# Urgent Field Safety Notice Product Correction

Product Name	List Number	Serial Number	UDI
Mixer	09D59-01 09D59-02 09D59-03	All	Not applicable

This Product Correction letter is to inform you of an issue with the ARCHITECT c Systems Mixer (LN 09D59-01, 09D59-02, and 09D59-03). There is the potential for the mixer blade, attached to the mixer with a screw and nut, to separate from the mixer. The missing mixer blade will result in inadequate mixing of the reaction mixtures leading to potential incorrect results (failed assay calibration, Quality Control (QC) out of range, and/or incorrect patient results). The impact on the test result may vary depending on the assay being performed and the viscosity of the patient sample.

## Appendix A: Mixer Inspection Procedure

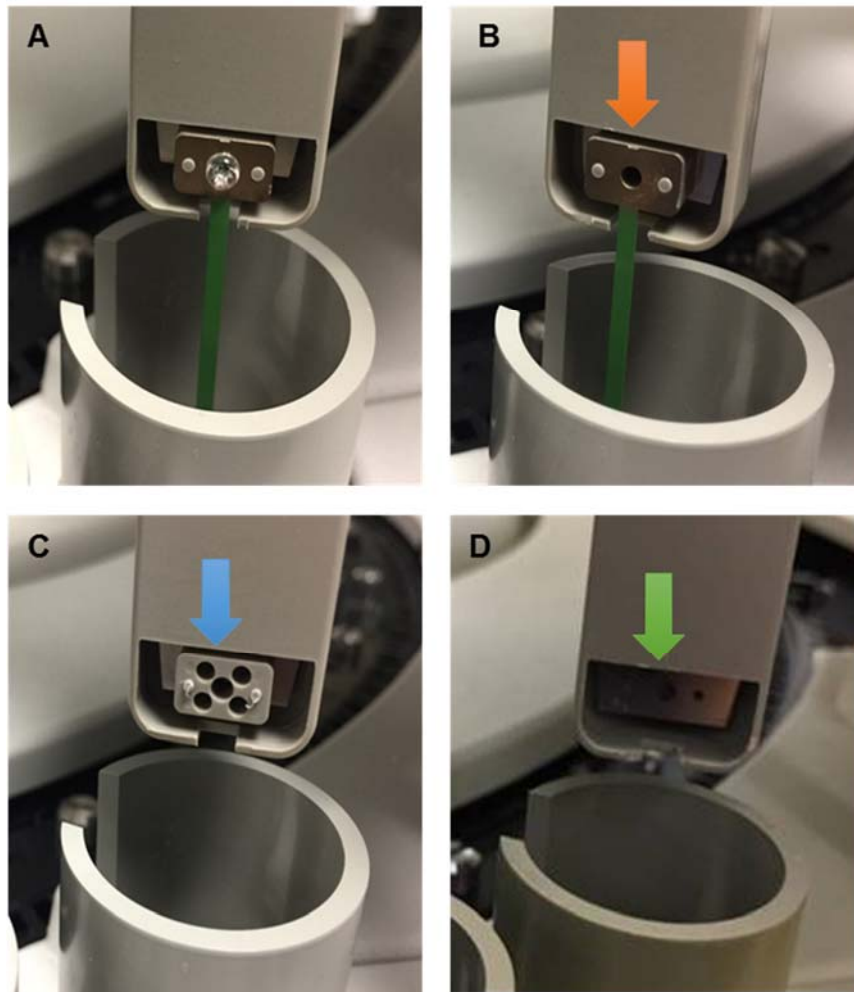
To inspect each mixer, open the rear cover of the processing module and inspect the mixer. Verify the mixer blade and screw is present.

If a mixer blade and/or screw are missing

The following pictures show a A) normal mixer B) mixer missing the mixer screw (orange arrow pointing to missing screw), C) missing mixer blade with spacer shim present (blue arrow pointing to missing mixer blade), and D) missing mixer and spacer (green arrow pointing to missing mixer blade and spacer).

1. Replace broken mixer. Refer to *Replace the Mixer (c4000, c8000, c16000)*<sup>1</sup>.
2. Replace the cuvette dry tip. Refer to *Replace the cuvette dry tip (c4000, c8000, c16000)*<sup>1</sup>.
3. Follow the instructions in **Appendix C** to inspect all cuvettes to ensure that the screw or nut did not fall into an individual cuvette.

## Appendix D: Additional Precautions for Weekly procedure *6021 Clean Mixers*<sup>1</sup>:

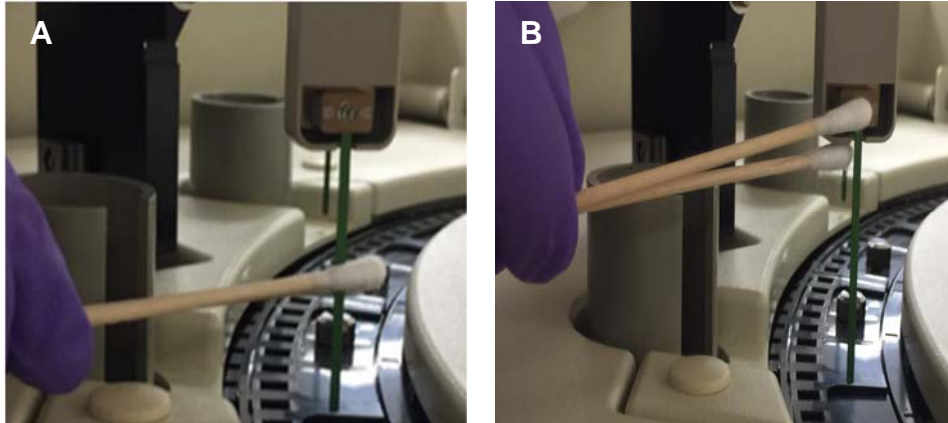
When performing weekly maintenance procedure *6021 Clean Mixers*<sup>1</sup>, it is recommended to not let the mixer screw and 70% isopropyl alcohol come in direct contact.

The below pictures show A) the proper cleaning of the mixer and B) improper contact of the 70% isopropyl alcohol with the mixer screw.
